## M-1987-116, Adequacy Response 1

**RE: Siskin Pit, File No. M-1987-116, Conversion Application No. 1 (CN1), Adequacy Review 1**

Please accept this response on behalf of Colorado Quarries for your first adequacy review letter dated May 3, 2024. Only permit narrative exhibits with changes are included as attachments to this response.

C-1 Access Road

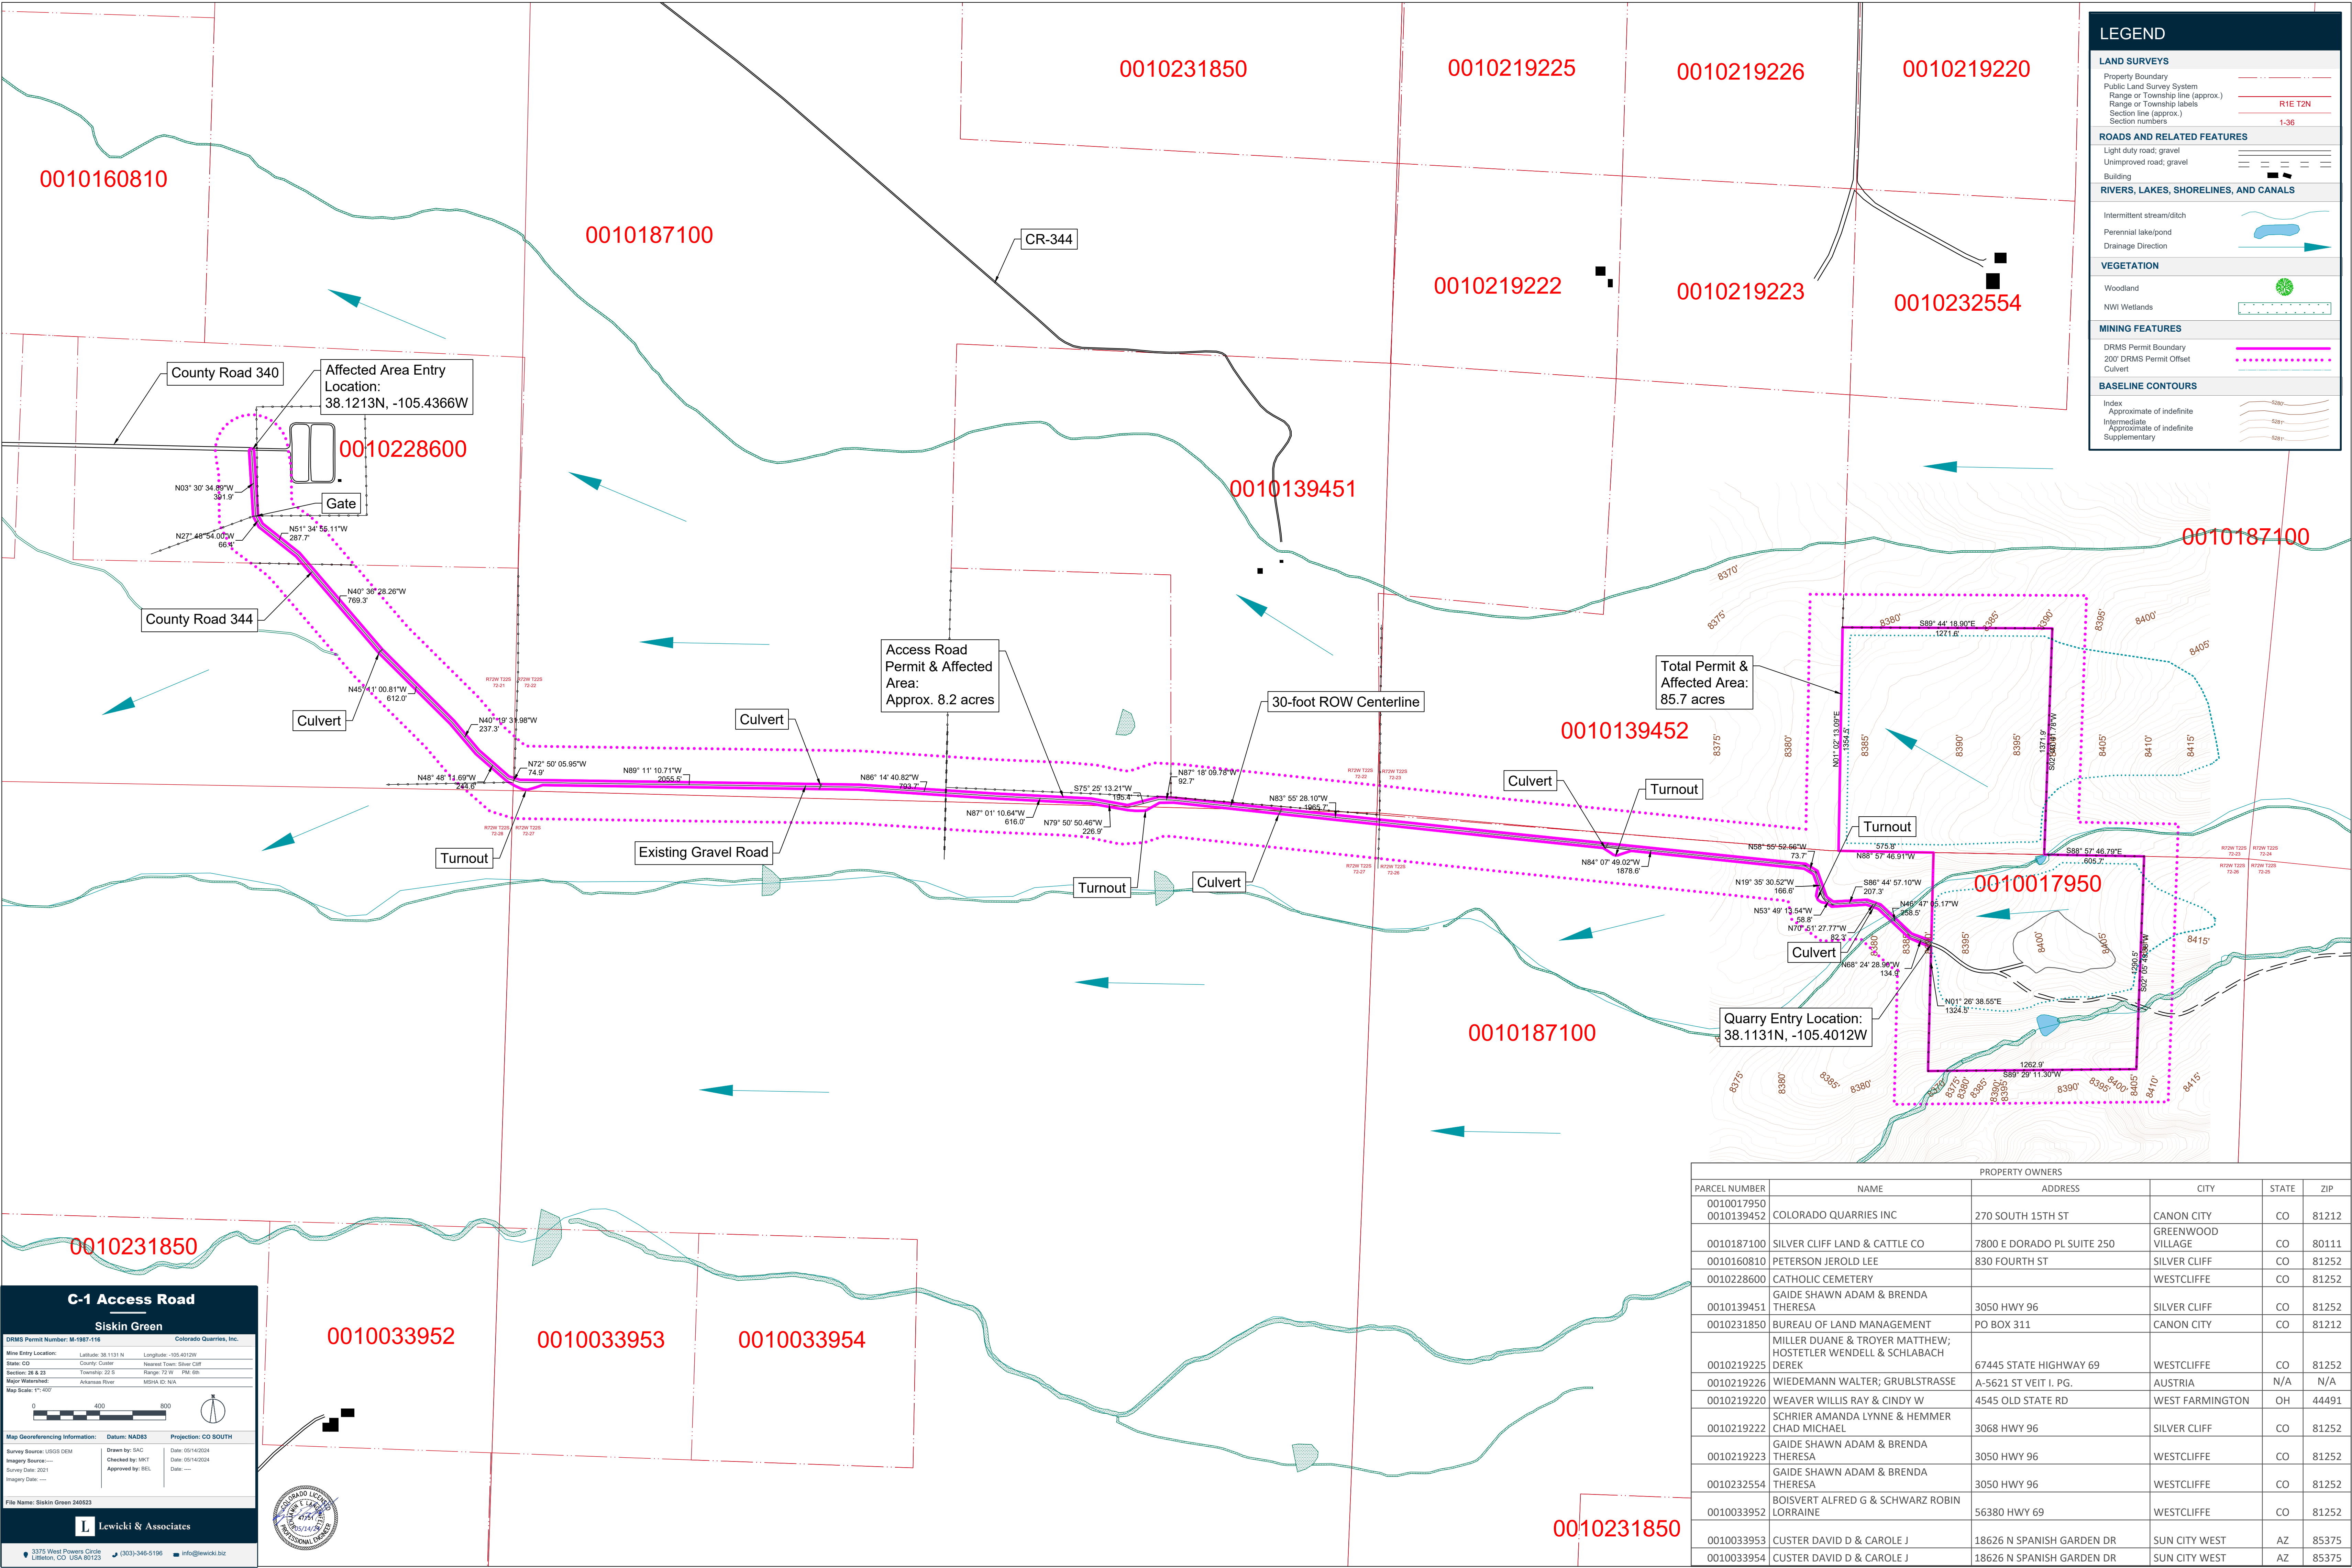
- *Parcel number 0010187100 is listed twice in the Property Owners table on Map C-1, but has different information for each entry.*
4. *Please describe this reasoning for this discrepancy to the Division or correct this on Map C-1 and any map including this parcel number.*

- *Exhibit D and the Introduction section describes the access road area totaling 8.2 acres. On Map C-2, the Access Road Permit & Affected area label states that this is approximately 8.7 acres.*
5. *Please update map C-1 to reflect the Access Road Permit & Affected area as being comprised of approximately 8.2 acres.*

This discrepancy was due to an error in labeling of parcels. Please refer to the revised Map C-1 with this error corrected.

Please refer to the revised Map C-1 with the corrected acreage of 8.2 acres.

F-1 Reclamation Plan

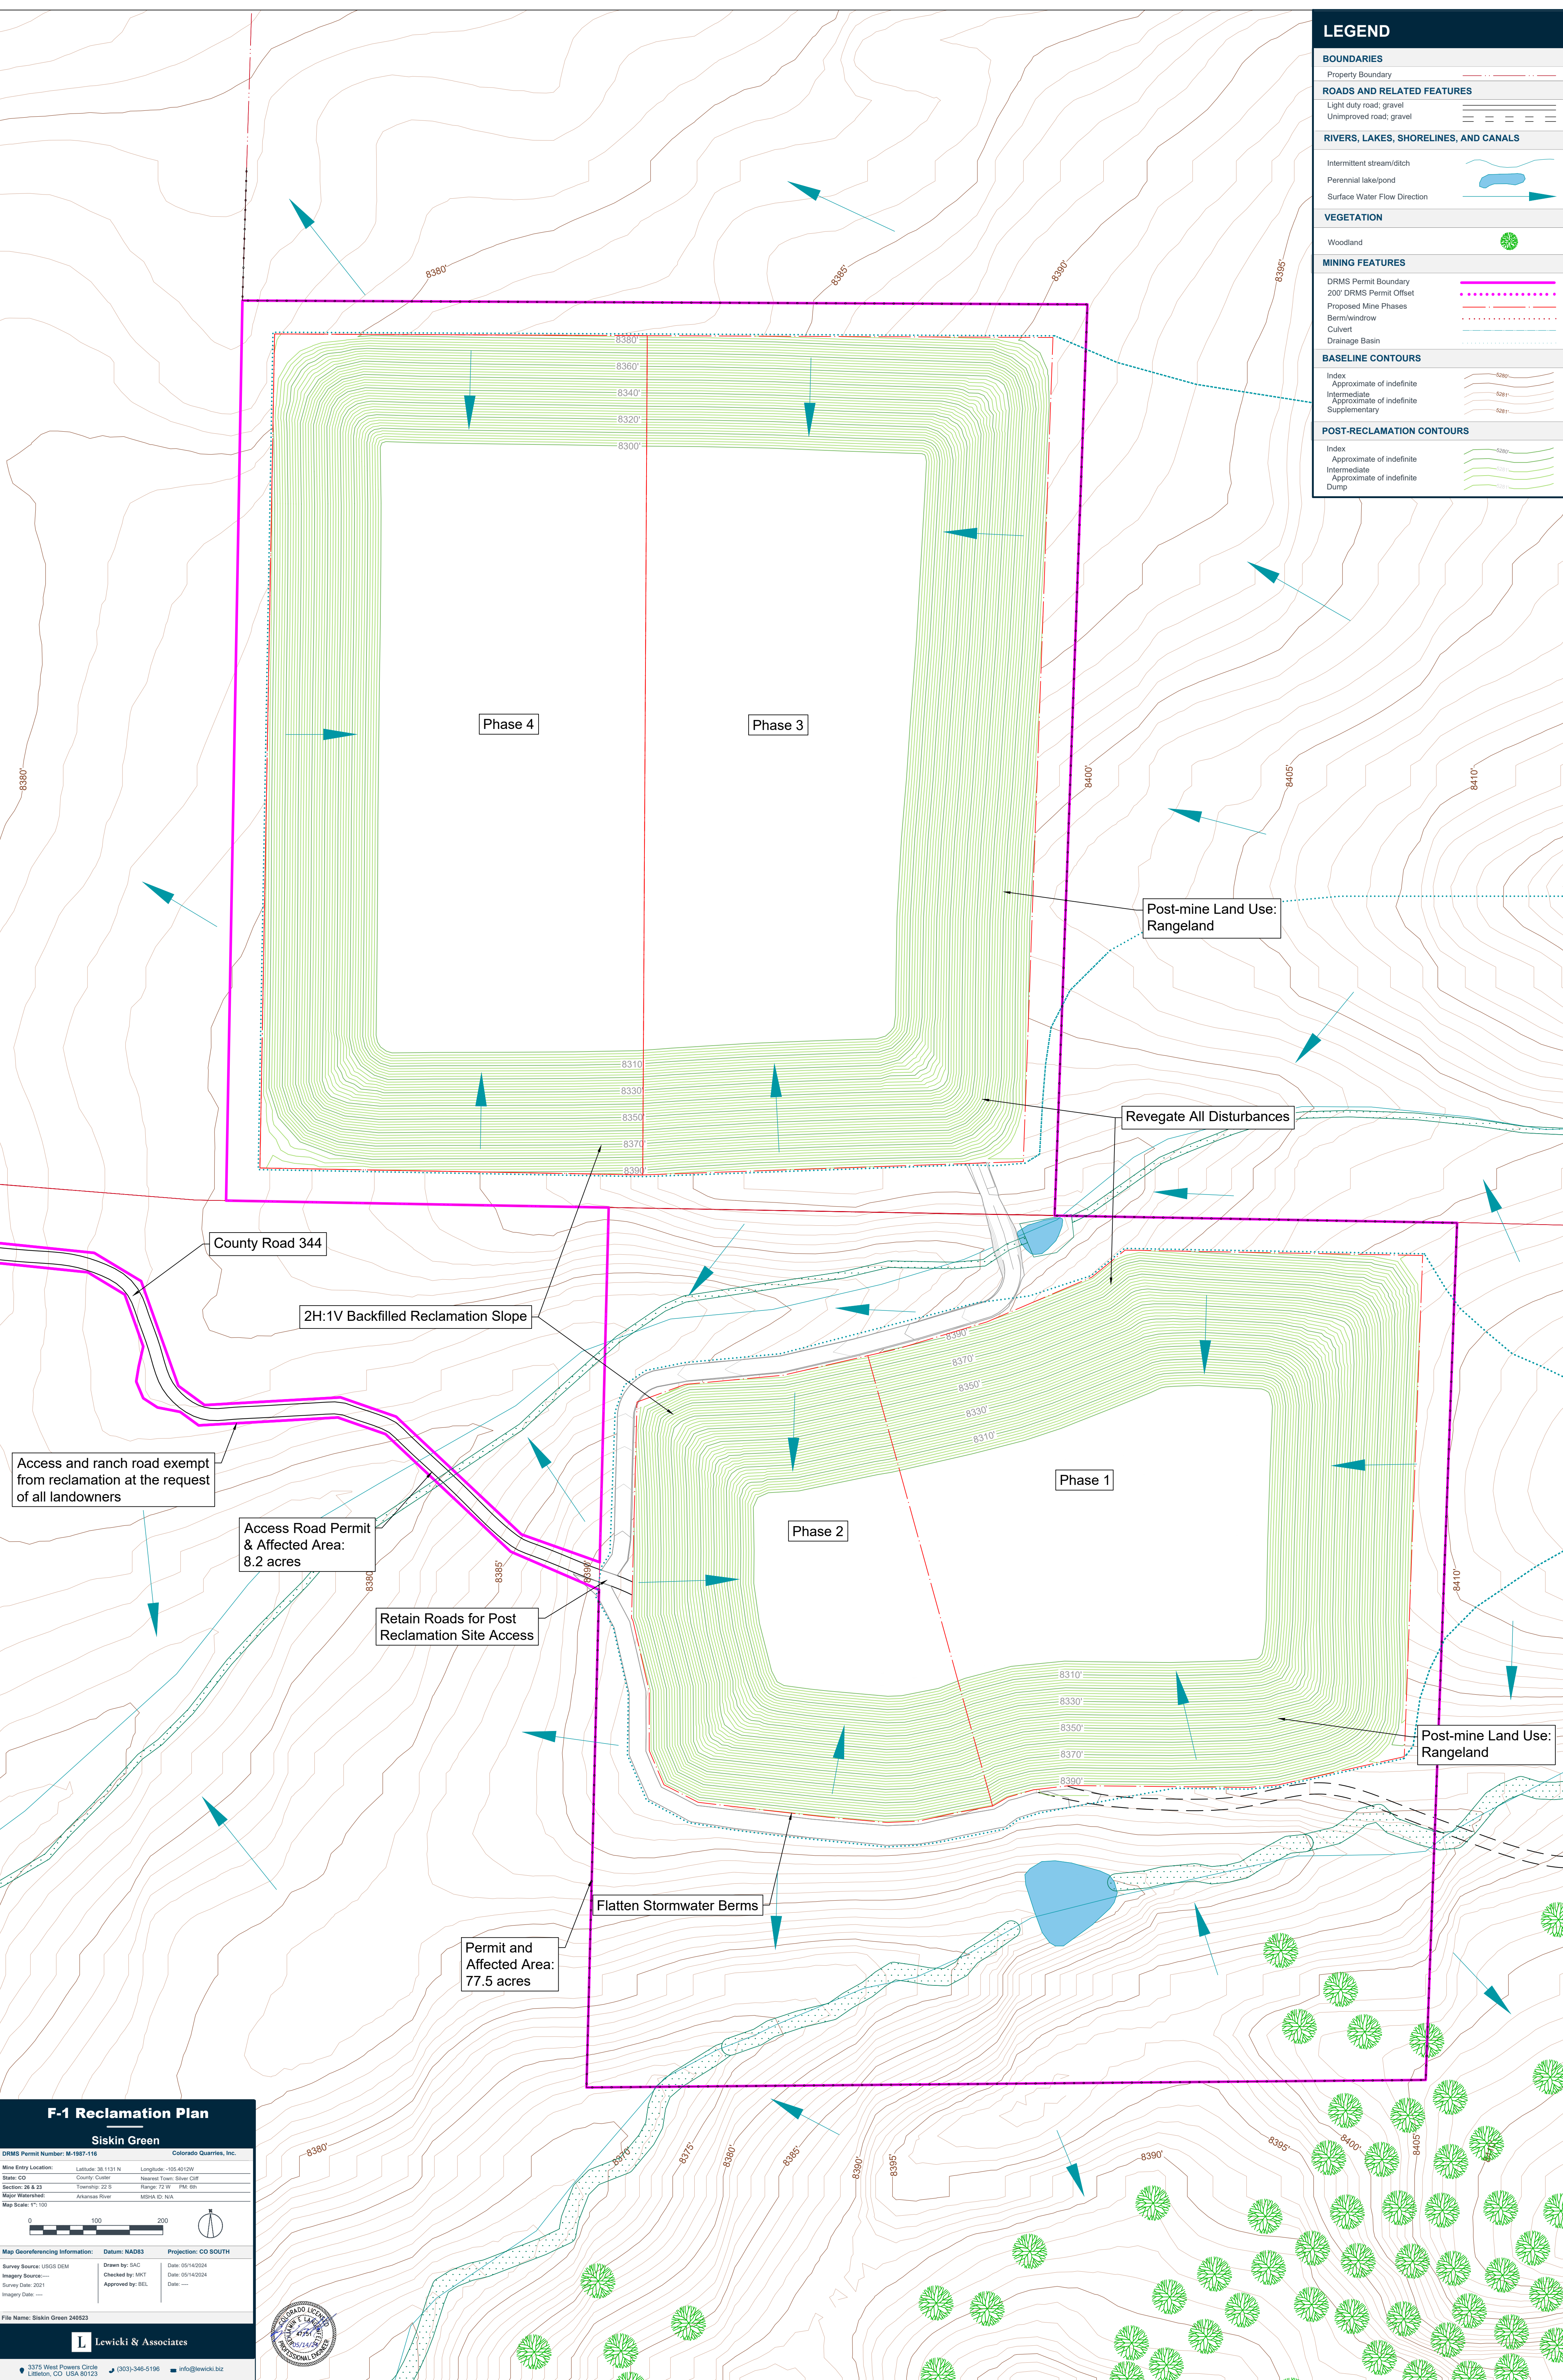
- *Map F-1 is not signed.*

*16. Pursuant to Rule 6.2.1(2)(b), the Applicant shall submit maps that have been signed by a registered land surveyor, professional engineer, or other qualified person.*

Please refer to the revised Map F-1 with the required signature.

# EXHIBIT B

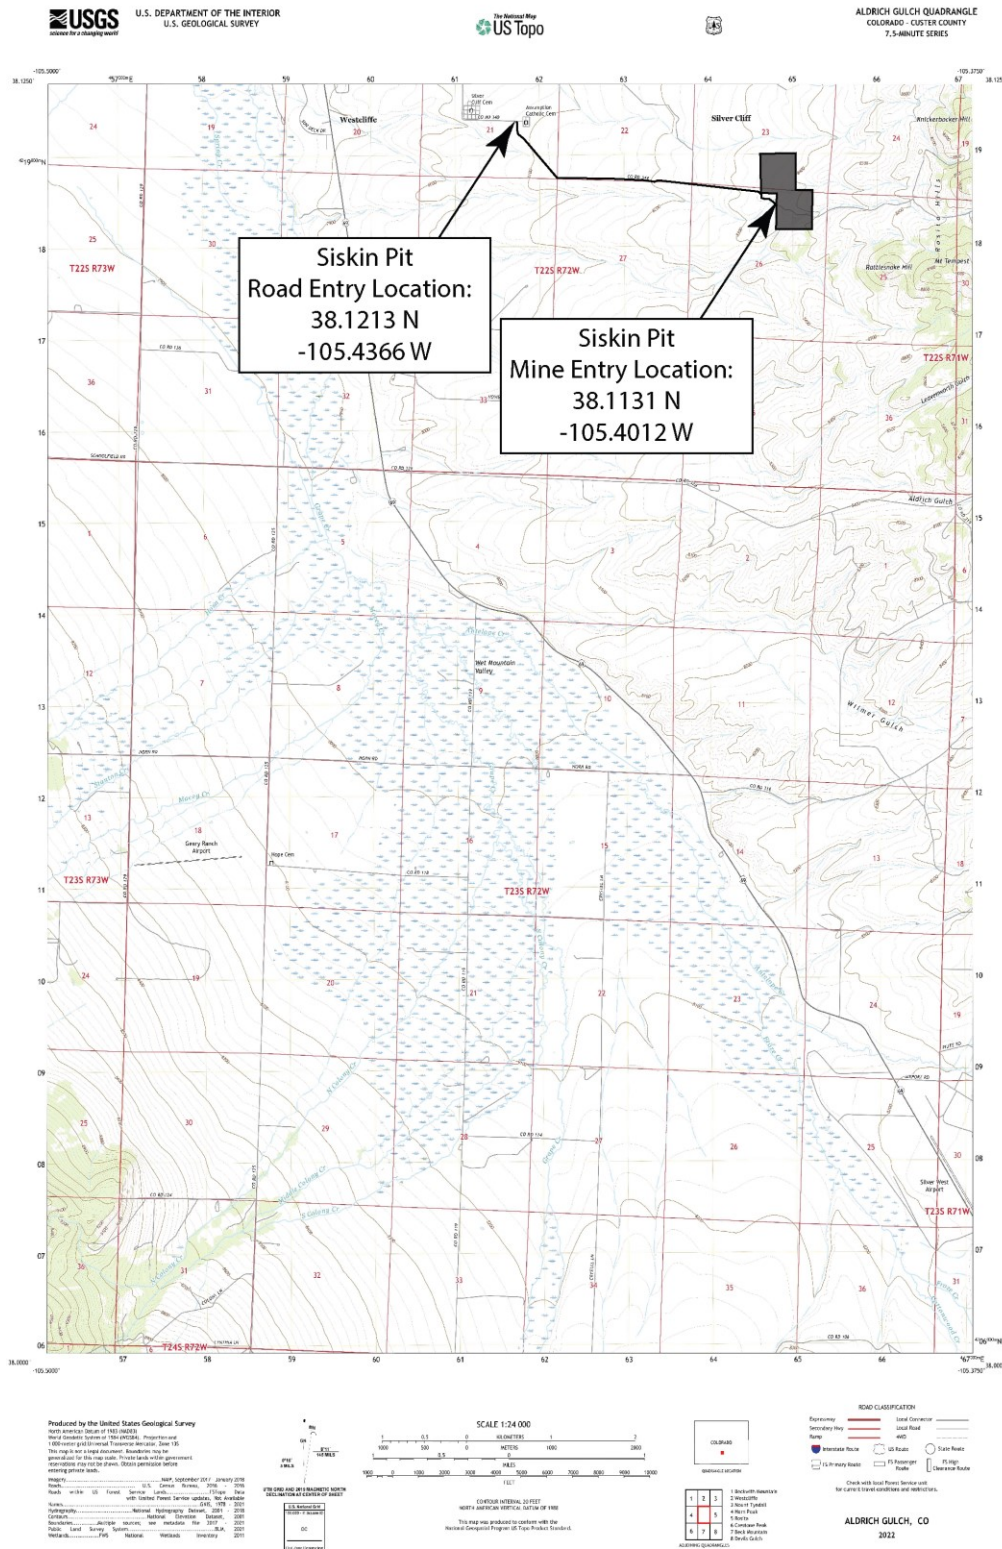
- *The physical copy of the Exhibit B Index Map is very faint and difficult to see.*
- 2. *Please resubmit this page as a PDF file that clearly illustrates the vicinity of the proposed site on a map that is compliant with Rule 6.4.2.*

A pdf of Exhibit B is attached to this letter.
